PROPOSAL:

Kevin Rhinehart requests a certificate of appropriateness for work at 1717 D Street, the Myron Wheeler House, a designated landmark.

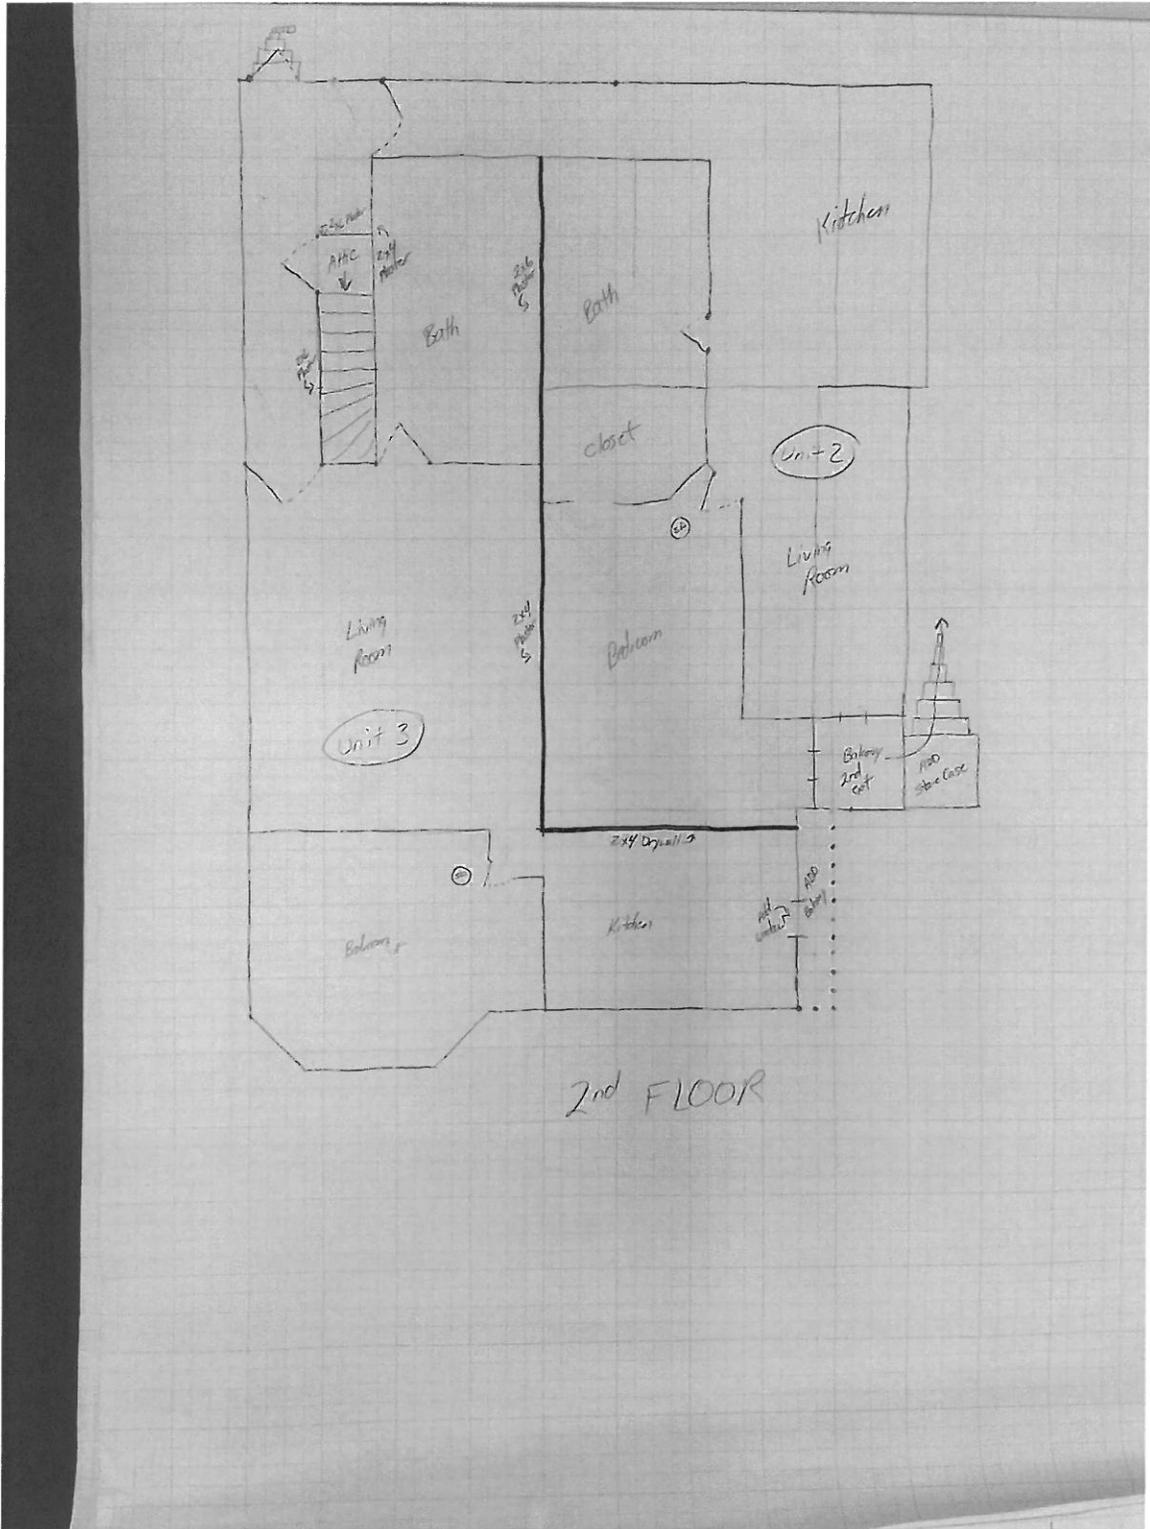
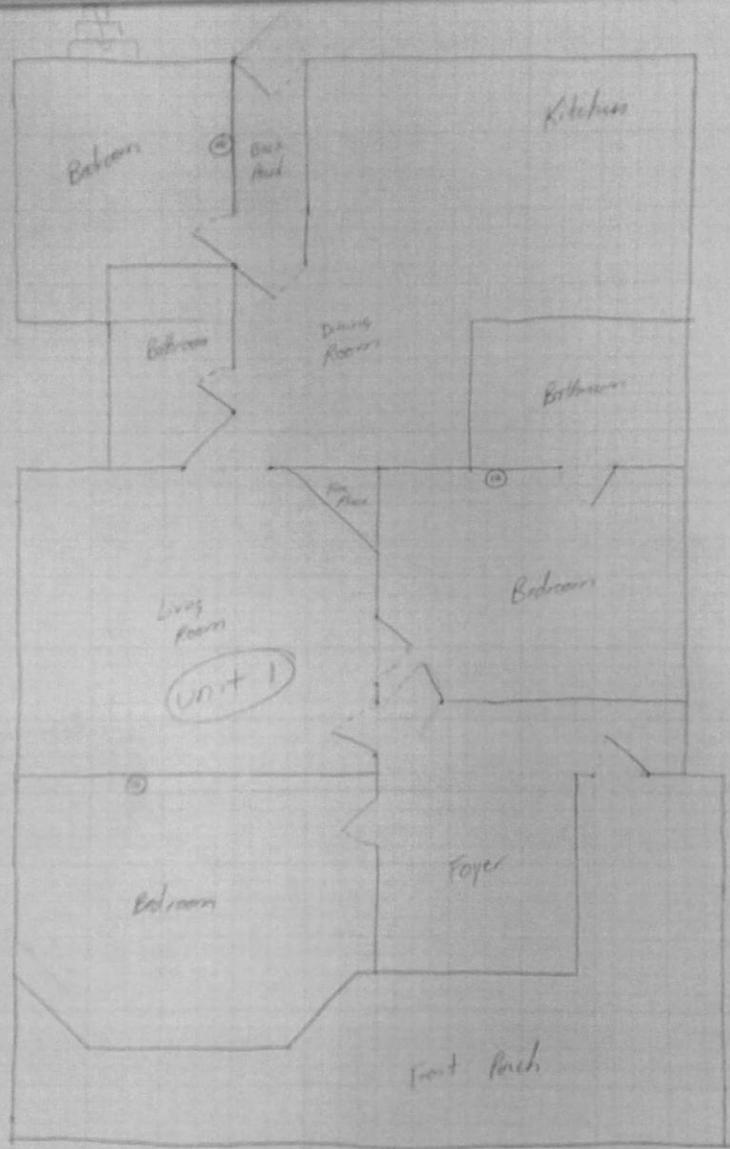
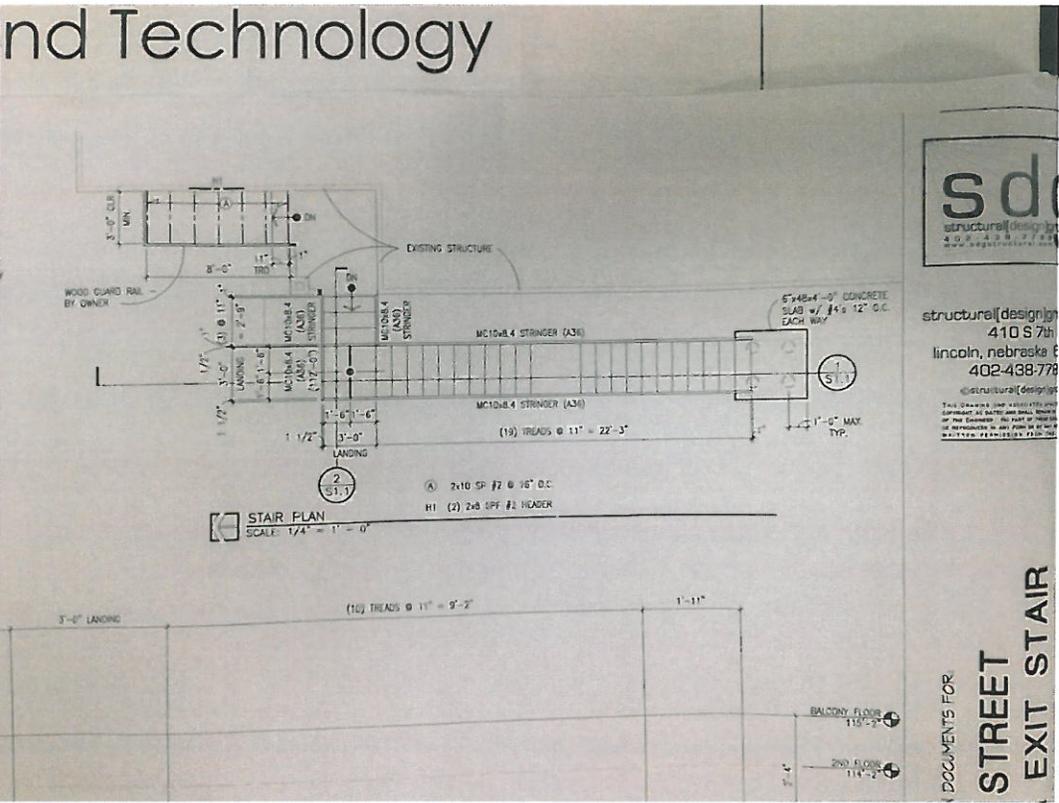
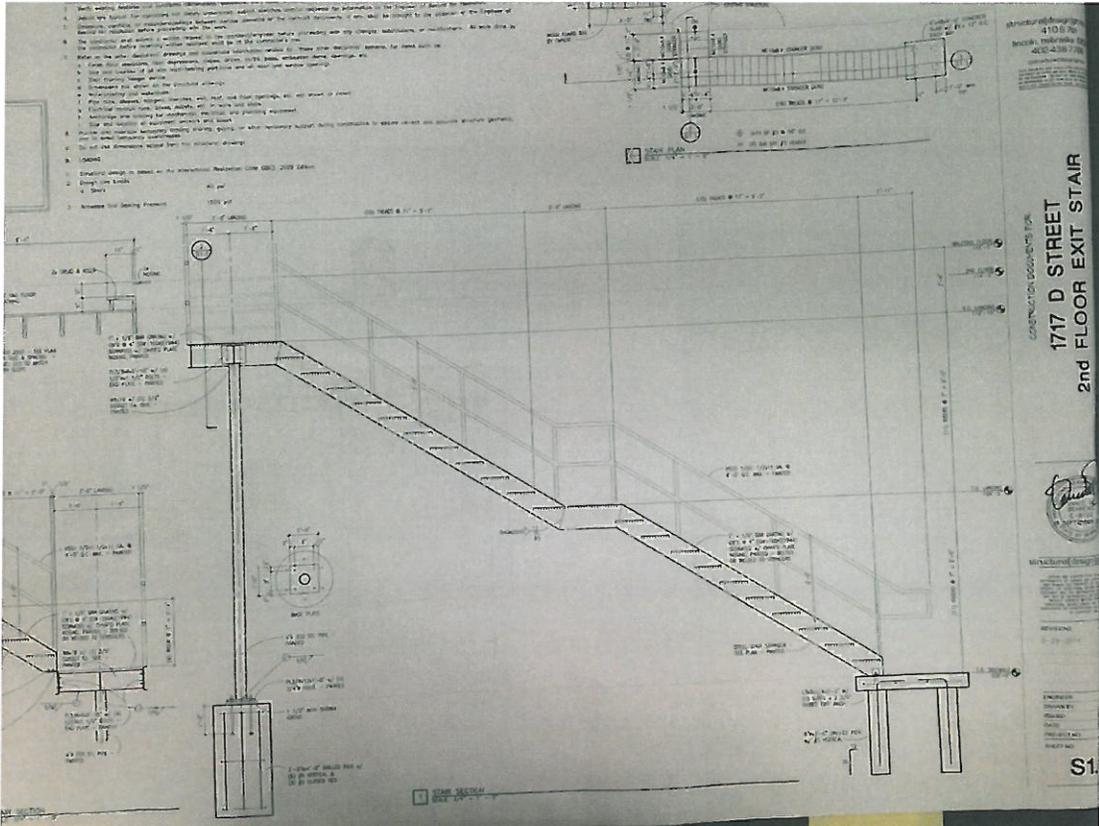
To complete that work, Mr. Rhinehart has requested to add a second egress route for the second floor units. (See attached plans.) The proposal is to add a window to the west wall above the front porch, accessing a wooden balcony to be added above the porch roof, connecting to the small upper porch inset at the northwest corner of the house. That porch would be modified to access a steel staircase extending down (towards the south) 23' along the west side of the house. The staircase would be 2'9" away from the west wall and approximately two feet from the west property line.

This modification would be highly visible from D Street and the public sidewalk. It would insert a window into the field of decorative shingles on the west wall and would require modification of both the north and west walls of the small upper porch.

The proposals do not meet the guidelines. Staff recommends that a certificate of appropriateness not be approved.

There appears to be a challenge in this case of reconciling the preservation guidelines and life-safety codes, but the hardship is at least in part the result of the act or omission of the owner in finishing the apartment interiors without sufficient prior planning of how to balance the various requirements. The Commission should weigh Mr. Rhinehart's testimony and explore with him possible alternatives. At the present time I do not have sufficient information on hand to recommend the certificate of exception.
